Browns Summit Creek Restoration Project Year 1 Monitoring Report

DMS Project ID No. 96313, DEQ Contract No. 5792

Subject: Response to Task 7 Draft Year 1 Monitoring Report Comments dated January 2, 2018
Browns Summit Creek Mitigation Project, Guilford County
Cape Fear Cataloging Unit 03030002
USACE AID SAW 2014-01642, CMS Project #96313

Figure 5 Year 1 Cross-sections

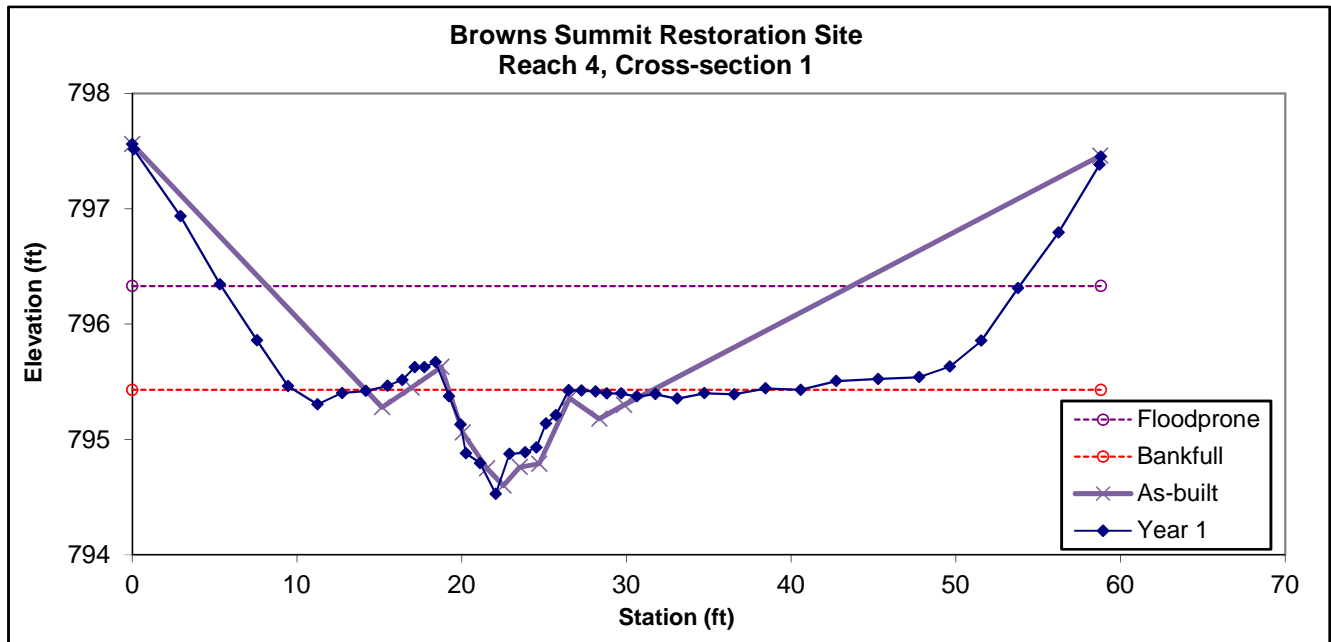
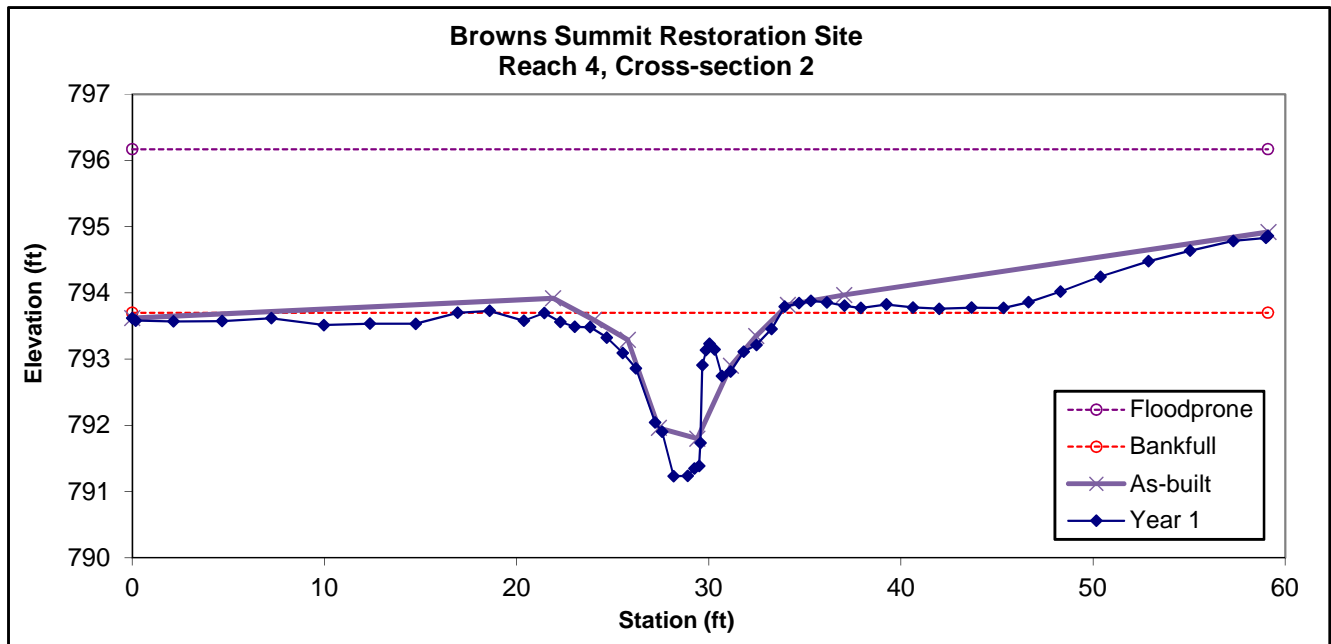
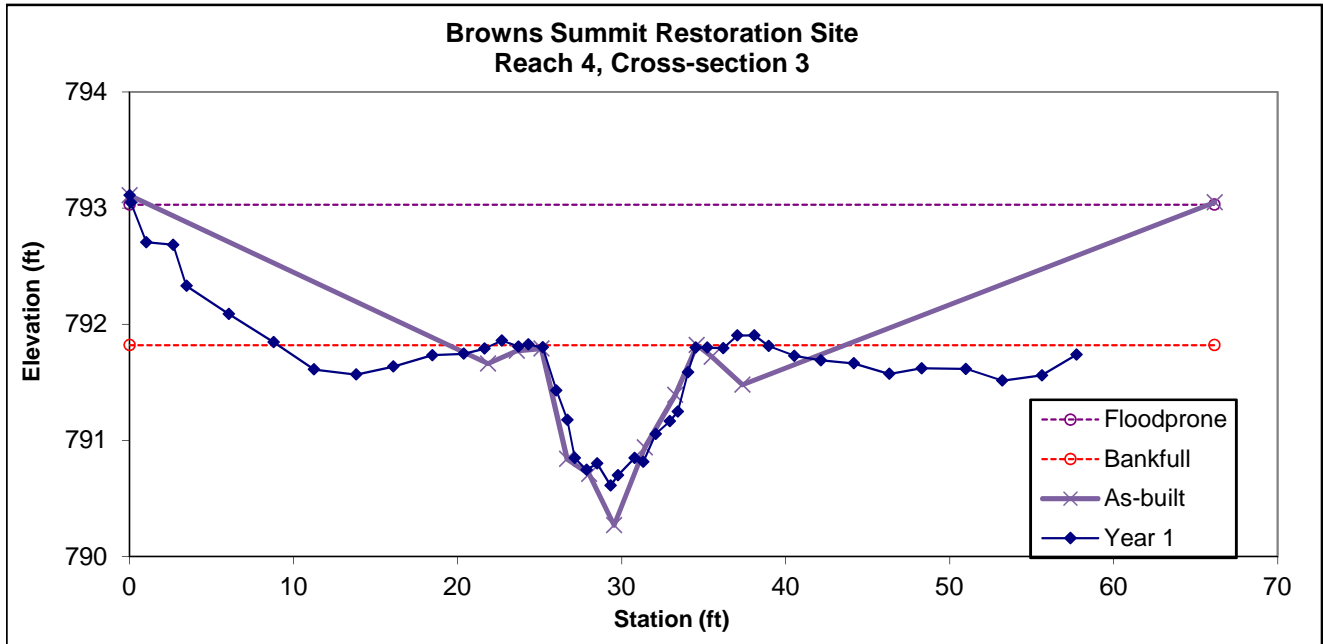
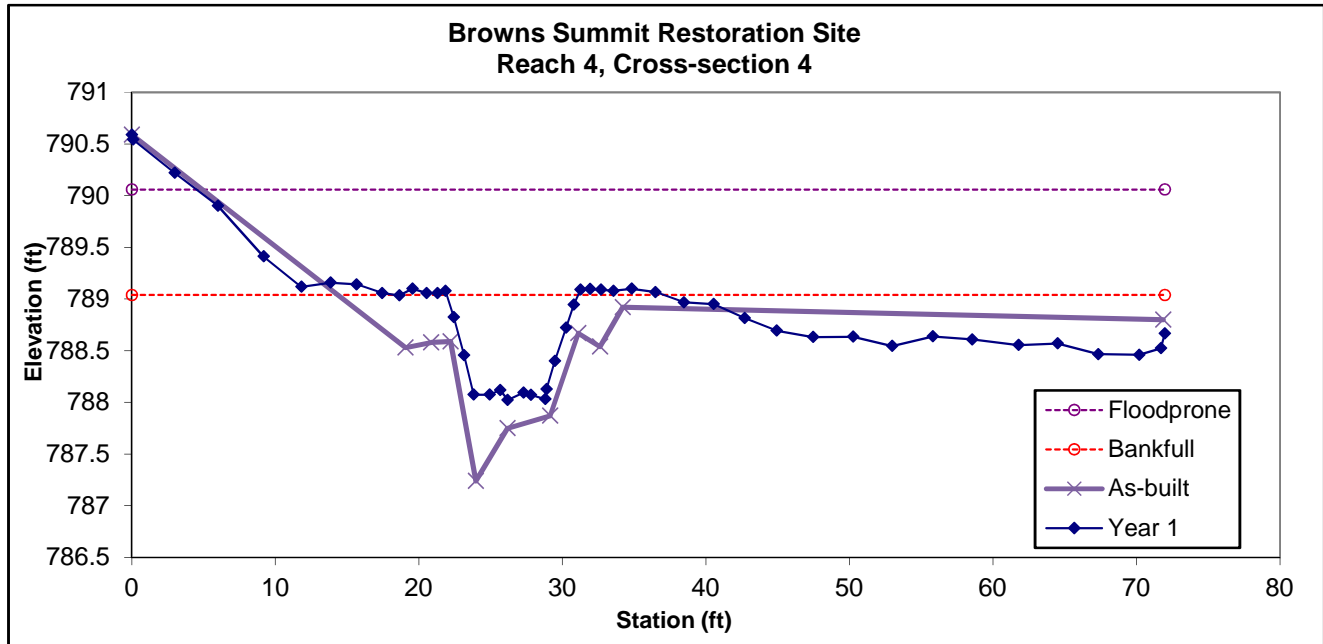
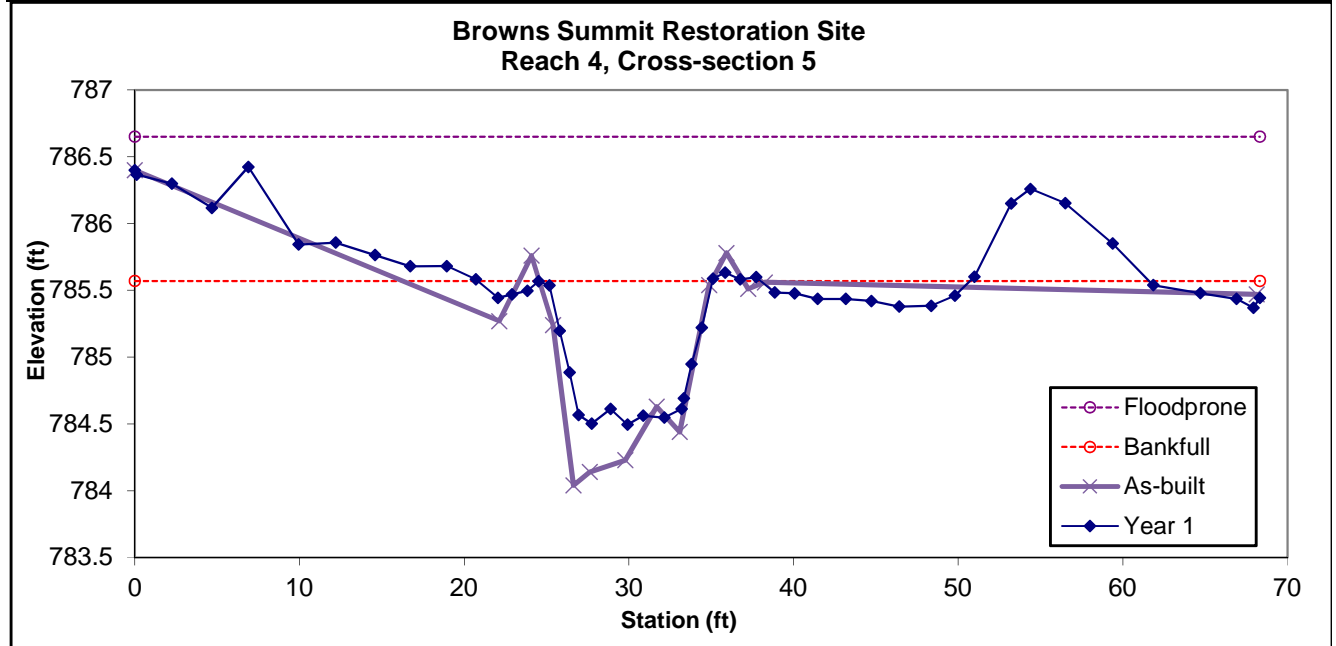
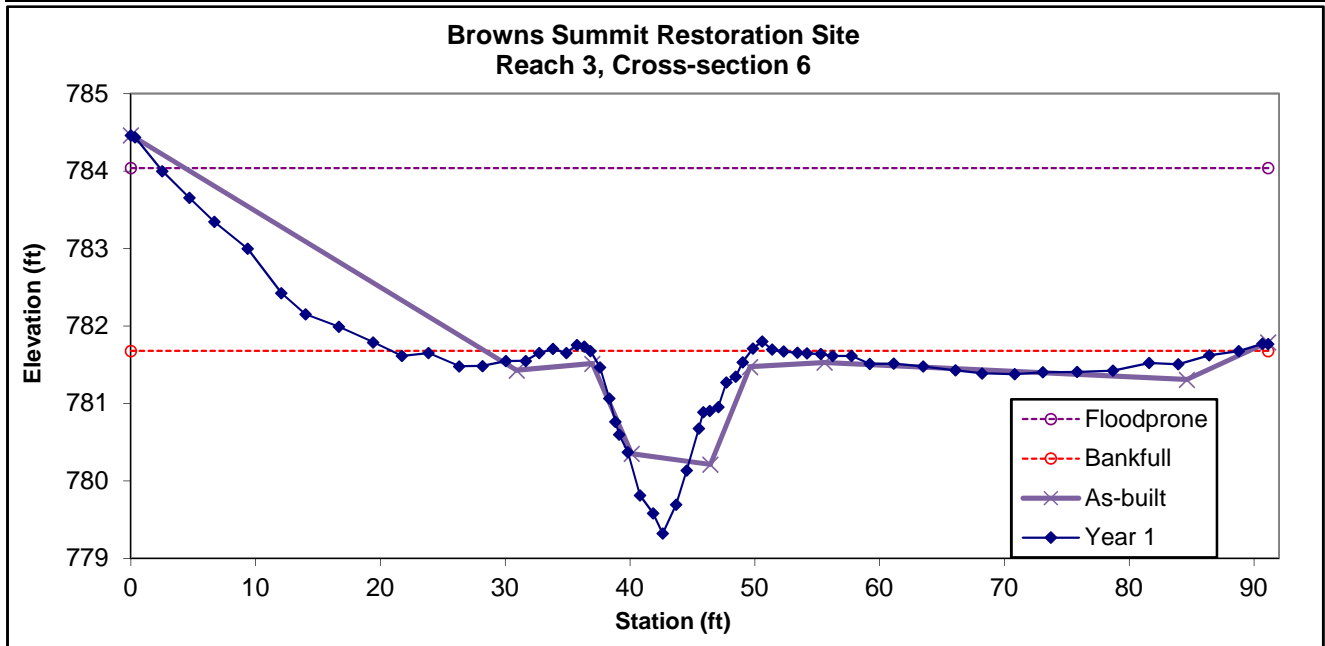
3. Section 2.1.1, page 4: The report states that certain cross-sections have shown minor fluctuations in their geometry as compared to their as-built conditions and that these fluctuations do not represent any trends toward instability based off visual field evaluations. Please state which cross-section you are referring to and explain the cause of these fluctuations and why there is no need for concern.

Response: All the cross-sections show some level of change between the As-Built and MY1 condition based on the overlays; however, we feel the change is due to survey quality and extents. The quality of the sealed as-built survey provided by the contractor was not discovered until the MY1 survey was overlain. The channel has not fluctuated as shown in Figure 5 (cross section overlays), has remained stable and is performing as designed. We now have Kee Surveying working on the site throughout the monitoring period and anticipate their surveys will capture exactly what is happening on-site in future monitoring efforts. The language in question has been removed and replaced to provide clarification of MY0 and MY1 cross section discrepancies.
